STAFF REPORT: 3/8/2023 REGULAR MEETING
APPLICATION NUMBER: #23-8235
VIOLATION NUMBERS: #693, 694, 695
ADDRESS: 269 WATSON
HISTORIC DISTRICT: BRUSH PARK
APPLICANTS: MEIR ISRAEL, ROSE VALENCIA
PROPERTY OWNER: ARBEN GJEKAJ
DATE OF PROVISIONALLY COMPLETE APPLICATION: 2/13/2023
DATES OF STAFF SITE VISITS: 3/29/21, 4/27/22, 8/25/22, 2/20/23

PREPARED BY: D. RIEDEN

SCOPE: DEMOLISH GARAGE, RECONSTRUCT SIDE PORCH, INSTALL FENCE (WORK COMPLETED WITHOUT APPROVAL)

Figure 1, by Applicant: (East) side elevation, showing proposed porch.

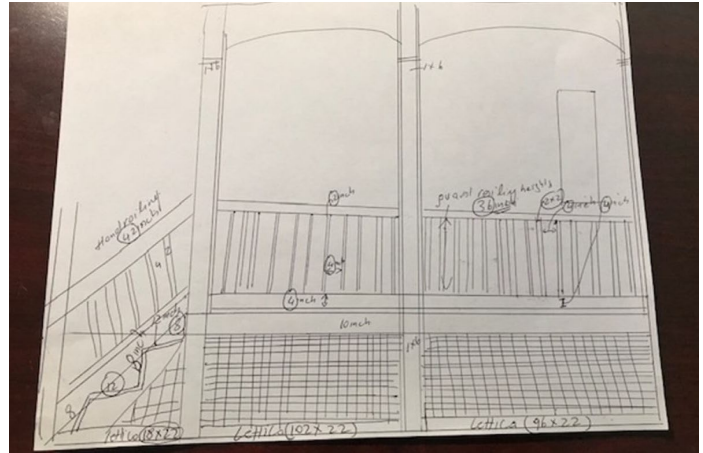
The applicant proposes to replace all wood decking, posts, railing and stairs on the east elevation porch, but retaining the roof, ceiling, arches and pediment support at the porch entrance. (See attached sketch and description.) Some wood fascia is replaced with wood. And some of the post headers have additional header application details that were added at the top of each post that were not original to the porch. The porch dimensions stay within their historic floorplan. However, the railing has been raised to 42" height. All wood is pressure treated wood. Staff requested information on paint or stain treatment of the porch and the skirting but has not received any information to date of this report. (See also Site photo 2)

- When the applicant last appeared before the Commission in September 2022, staff noted that the east porch was in the process of demolition. At that time, the applicant was invited to include this work in their application but did not respond.
- The square Tuscan capitals of the wood posts, the wood railing and the brick pier supports of the wood posts of the original east elevation porch are distinctive character-defining features of the building.
- The original porch had brick piers under the wood deck that supported the wood posts. These brick piers have been removed and replaced by wood posts by the current construction of the new porch.

- The original porch posts had square Tuscan capitals that have been replaced by simple ledges. Staff observed that wood plate detail has been applied to the archways that were not previously present. These modifications in design are not appropriate and do not follow the Secretary of Interior Standards.

- Staff observed that the railing design is different from the original design in the following ways:
 - It introduces a handrail along the steps
 - The railing design has a 2x4 sub-rail and lower rail running face-forward along the top and bottom of the railing, creating a thicker, less elegant design that is not appropriate to the detailing of this property's historic architecture. The original railing had a simple upper and lower rail that was less obtrusive and could be replicated by rotating these rails so that they are less visible.

- While the railing height approximates the original scale, the design of the railing has created an excess of bulk and thickness that has exceeded the historic finesse and elegance of the original design of the porch railing. It is staff's opinion that the new railing does not meet Standards 2, 5 and 6.

- The installation of skirting should be installed behind framing, per National Park Service Brief 45 "Preserving Historic Porches". Larger vertical boards should divide the skirting a the location of columns/piers to continue the porch's vertical support line from roof-to-grade. This house formerly had brick columns that were destroyed at these locations, which could have served as this vertical support line that is lost. It is staff's opinion that both the restoration of the brick piers, with upper and lower framing and then placing the skirting behind these elements, the skirting would then meet the guidelines as described in Brief 45.

Staff finds that the reconstruction of the east porch posts, replacement of brick piers with wood, redesign of the railing and introduction of skirting does not meet the Secretary of Interior Standards for the following reasons:

- The east porch railing, the applied detailing to the arches and the altered post design destroys and alters the original features that characterizes the original railing and original square Tuscan capitals of the posts, which are historic character defining features of the building.
- The replacement of the brick piers from the east porch with wood posts that are obscured with skirting that is neither framed nor follows historic standards.

Staff therefore recommends that the Commission issue a Denial for the above work items, as it do not meet the Secretary of the Interior's Standards for Rehabilitation, specifically Standards:

- The applicant relocates the east gate of the chain link fence to the brick corner of the house, behind the east porch, painted black.
- The deck be painted a color that matches Color System C color scheme of the HDC color guide.
- The applicant provides HDC staff a review of the above items before installation.

Sanborn V3, P117, 1921, showing the original garage location and materiality.

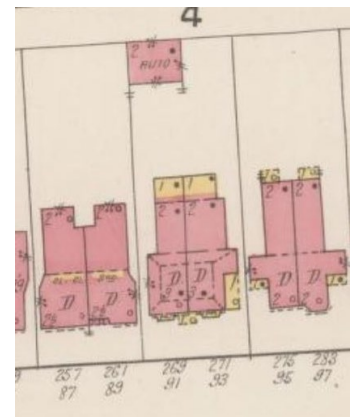
- Because staff has not received information from the applicant regarding the condition of the garage prior to its demolition, staff has utilized images from Sanborn maps and Google Street view to yield the following observations:
 - The 1921 Sanborn map shows the presence of a two-story brick garage that predates the concrete block garage at the northwest property corner.

- The 1971 Sanborn map shows the presence of a concrete block garage prior to the historic designation of Brush Park in 1980. *(see Sanborn above)*
- Staff observes from Google Street images that the building appears to be concrete block construction and not likely to be original to the time of the construction of the house.
- Staff estimates the demolition occurred sometime between April and August of 2022.
- It is staff’s opinion that the concrete block garage that was demolished by the applicant was not the original historic garage as depicted in the 1921 Sanborn, and based on the limited information available, the garage was non-contributing.

Site Photo5, by Staff February 20, 2023: (South) front elevation, showing front fence installation.

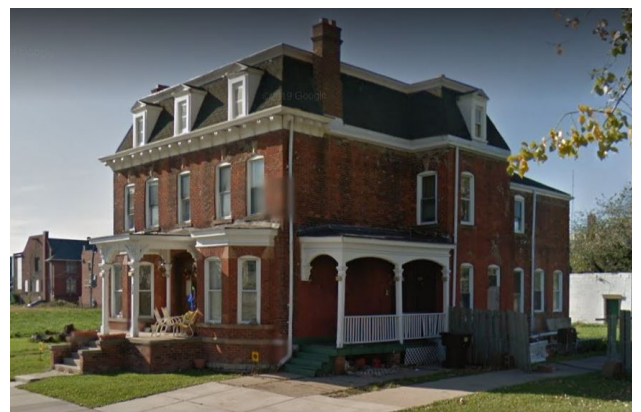
- Staff observed that the front yard fence is over the 3’ allowable height for front yards according to the HDC Fence and Hedge Guidelines. However, staff observed that Brush Park has fences in the front yard that are 4’ high similar to this fence. While the color and the metal material of this fence are appropriate, the execution of its installation has some of the top and bottom rails disjointed. *(See Site photos 2-3)*

- The chain link fence at the side and rear of the property is appropriate and does meet the HDC Fence and Hedge Guidelines. However, staff offers the opinion that a more appropriate location for the chain link fence gate would be at the corner of the brick east porch entrance, rather than at the corner of the wood post of the east porch, so that the height of the fence does not obstruct the detailing of the building’s architecture. *(See Site photo 2)* Also, staff offers the opinion that the fence be painted black to create some continuity with the front yard fence.

- Staff has no issue with the chain link fence, but as noted above, offers the opinion that the east gate be more appropriately located at the brick corner of the east entrance of the house to allow the east porch be unobstructed as staff has identified the east porch as a character-defining feature of the house and should not have new features attached in front of it.
